ADDENDUM NO. 1

South Walnut Street (Winslow to Ridgeview) Sidewalk Project

Issue Date: November 30, 2021

Item No. 2: ADDITIONAL INFORMATION OR CLARIFICATIONS – INSPECTION HOLES

Inspection Hole Locations

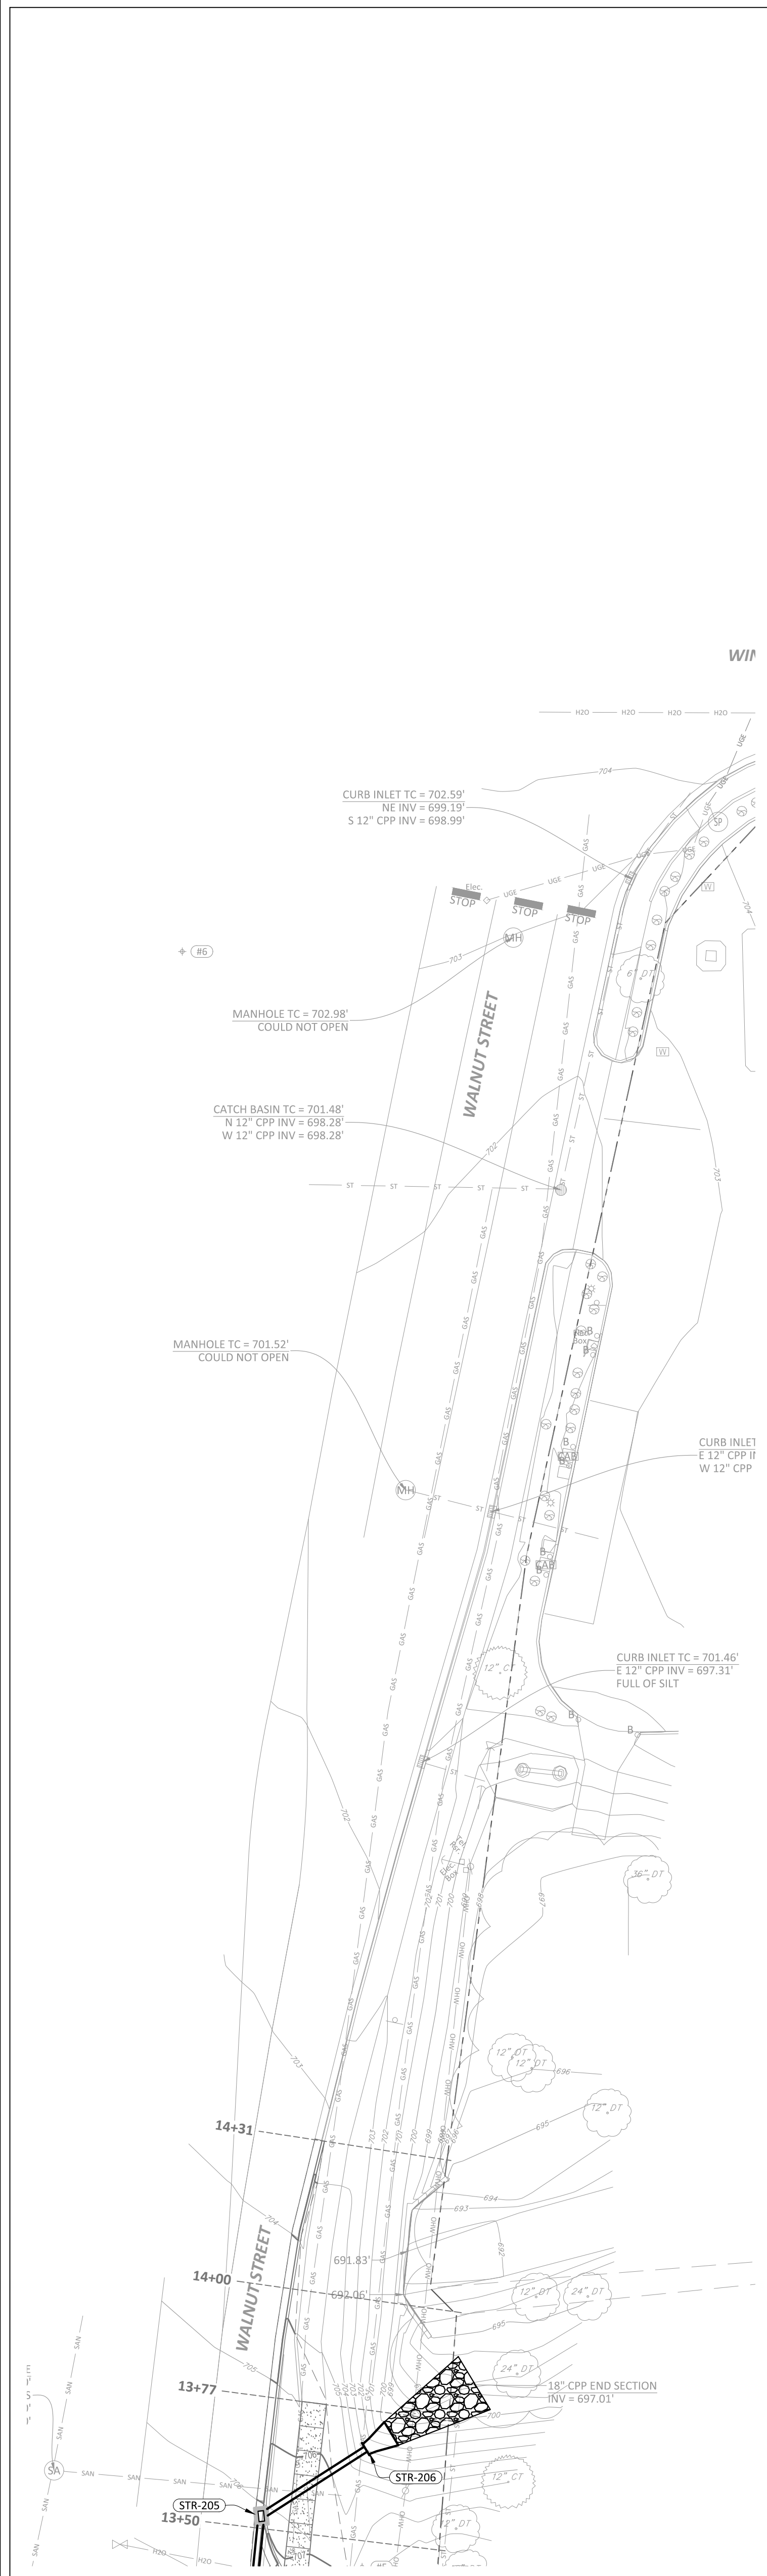
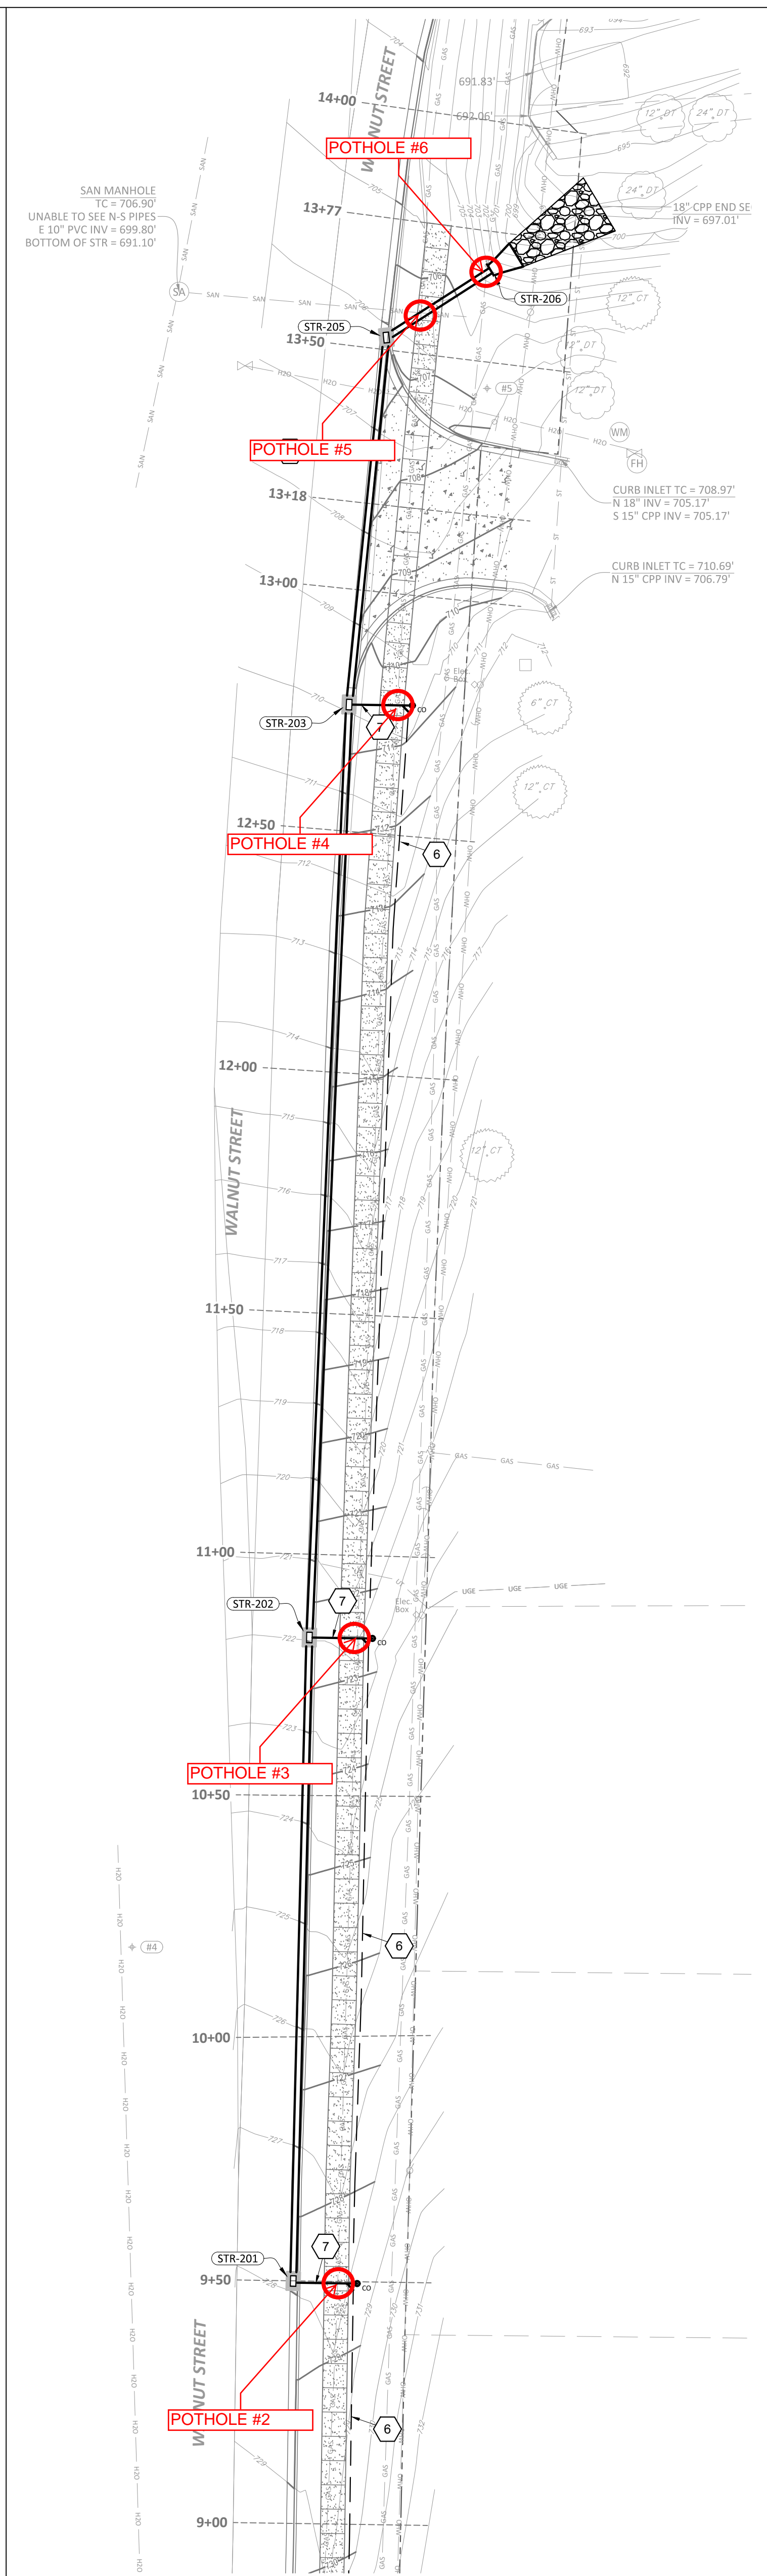
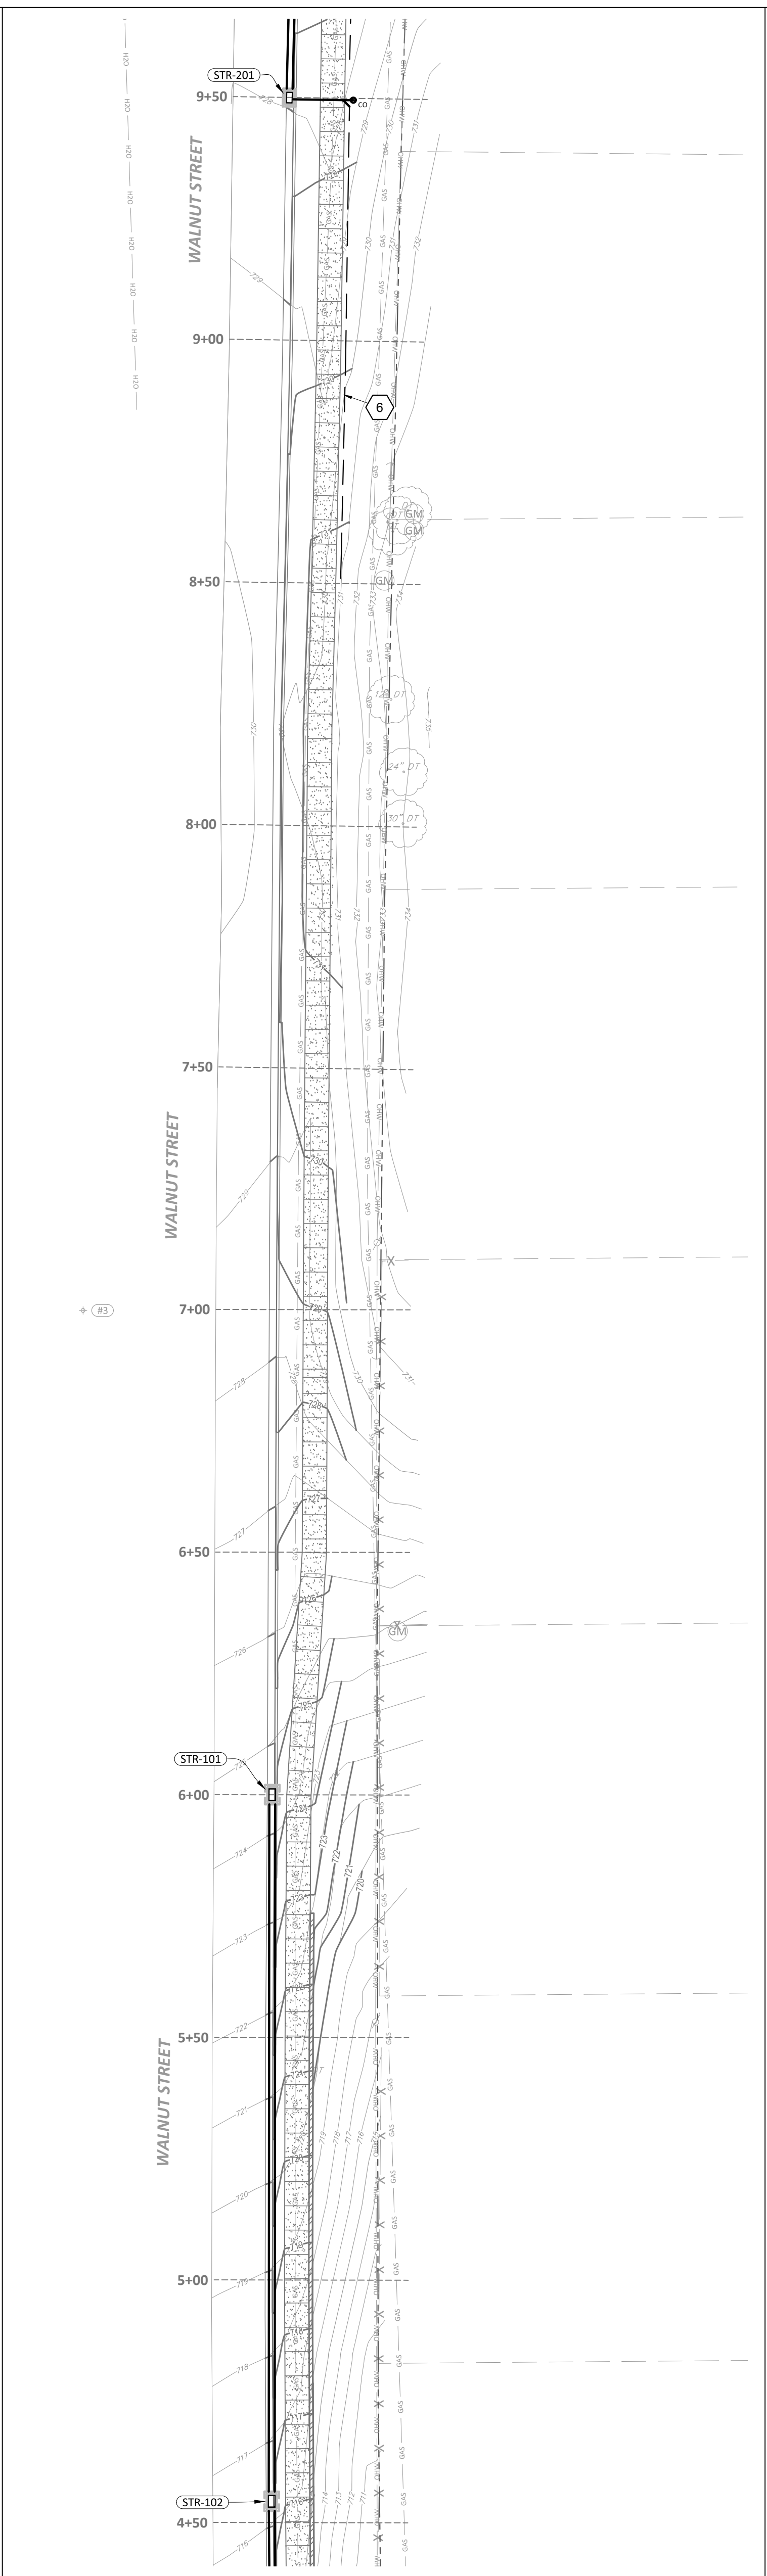
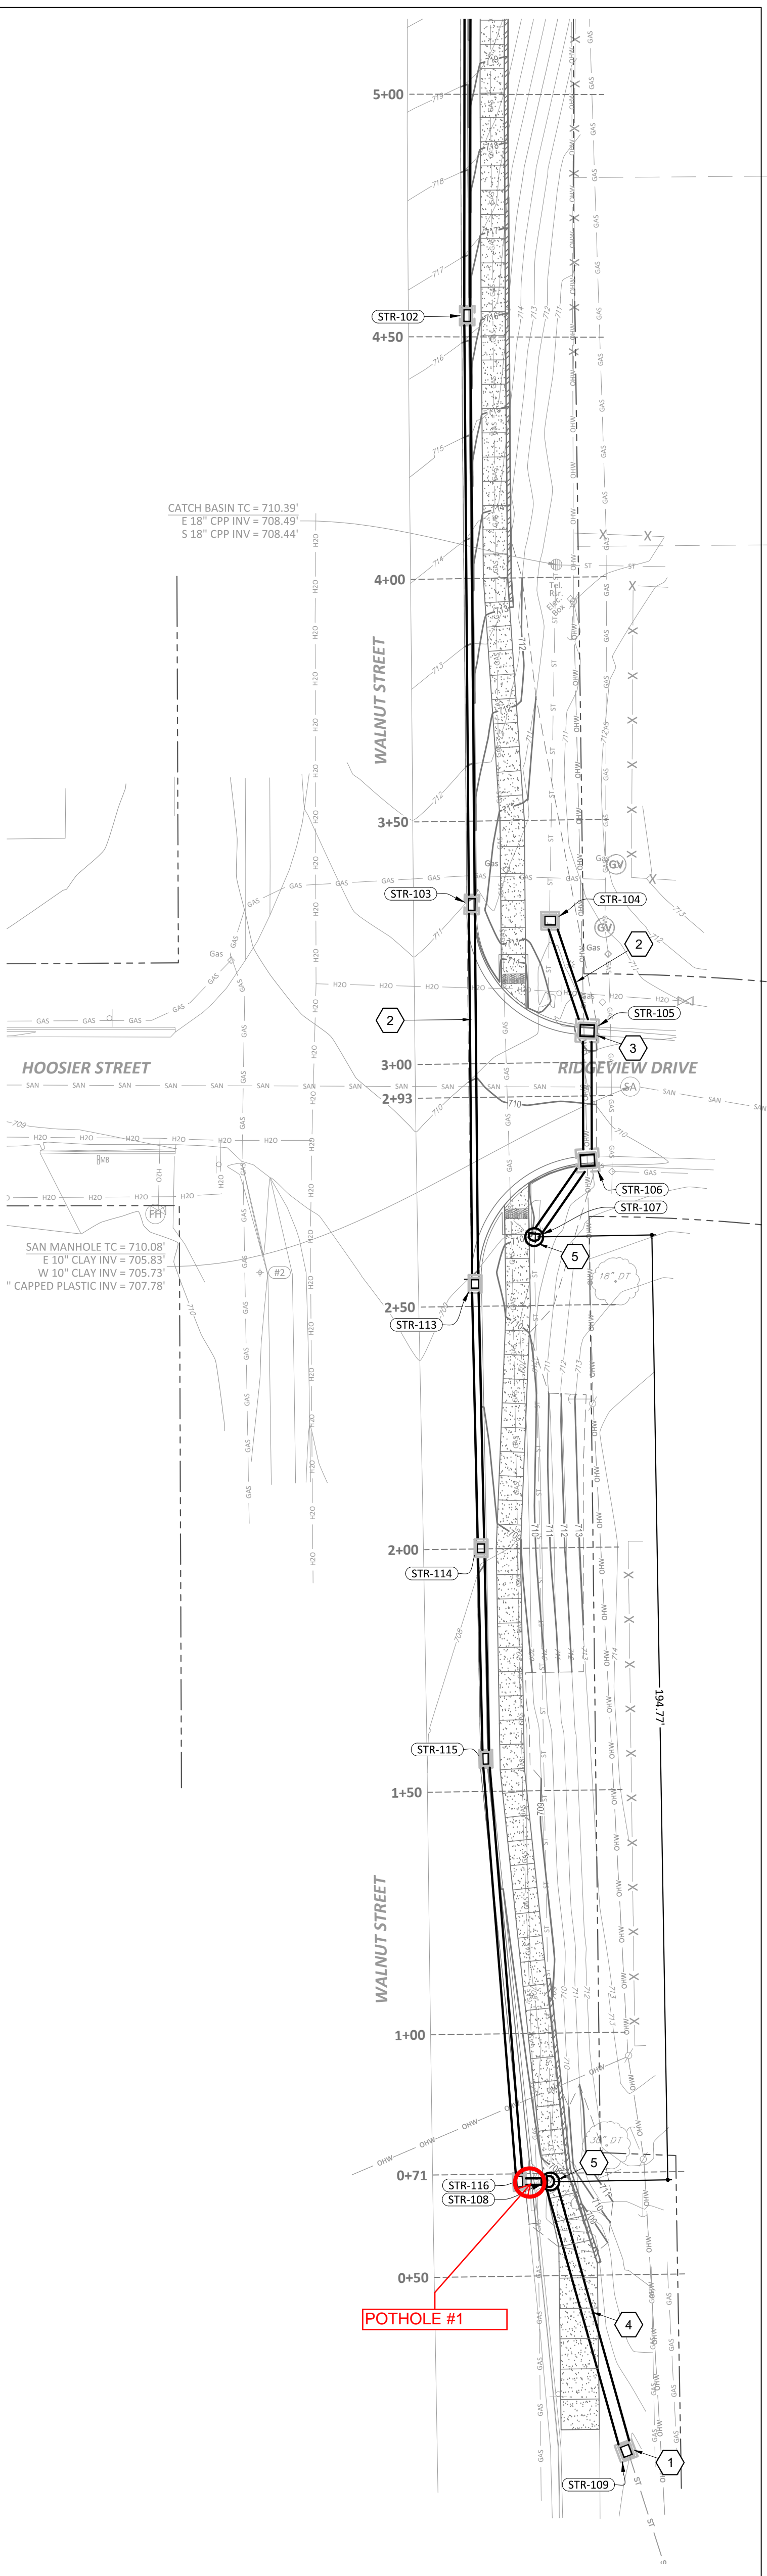
The Contractor shall complete inspection holes to verify the depth and location of gas lines prior to ordering stormwater structures. Required inspection hole locations are provided in the attached document. The results of the inspection holes shall be provided to the Engineer at least ten days before the contractor orders materials. If unexpected conflicts are identified, then the Engineer will provide updated structure information to the Contractor. Inspection holes will be paid for at the contract unit price per each, Pay Item: 107-09358 Inspection Hole, Deeper Than 3 FT. The cost of all work pertaining to inspection holes shall be included in the cost of this pay item. Inspection hole work will have no effect on the allowable project duration days. The contractor shall be fully responsible for any delays or additional costs that arise if inspection holes are not completed as directed within this item.
